# TECHNICAL INFORMATION

## RECALL ABS Modulator Plate Reinforcement

No: RB148  
Ref:  
Issue: 2  
Date: 25 April 2005

Discovery Series II (LT)

Figure 1

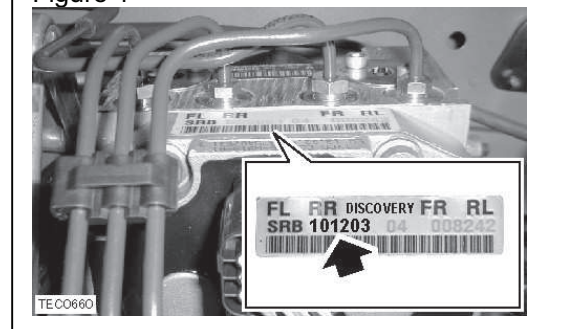
3. Note and record the service part number on top of the modulator. (Figure 1)
4. If the component part number observed on the tag is **SRB101203** or **SRB500051**, claim Option A. No further action is required.
5. If the component part number observed is different from SRB101203 or SRB500051 go to the following section "Installation of Modulator Plates and Screws."

Figure 3

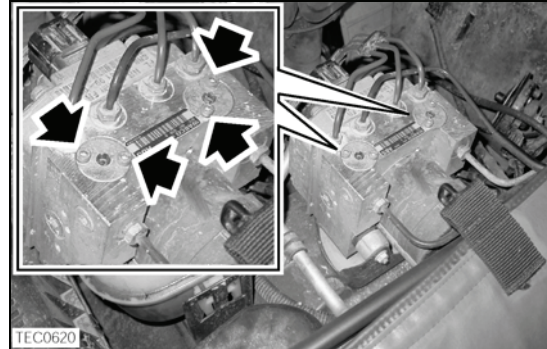
2. If the Allen screws were removed successfully, install the Recall kit components as follows:
  - Position the new reinforcing caps with the recess facing downwards over the top of the existing plates.
  - Verify that the recess in the cap clears the plastic clip. (Figure 3)
  - Install the new Allen screws (Figure 4) and tighten to **6 Nm (4 lb.ft)**.
  - Claim Option B.
3. If any Allen screw cannot be removed, perform the following:
  - Refer RAVE or GTR section 70.65.49 and replace the ABS modulator (SRB101203) following WSM procedures.
  - Claim Option C.

**CAUTION:** The plates provided in Recall parts kit SWO500010K are intended to be installed over the top of the original plates using the new longer screws to secure both plates in position.
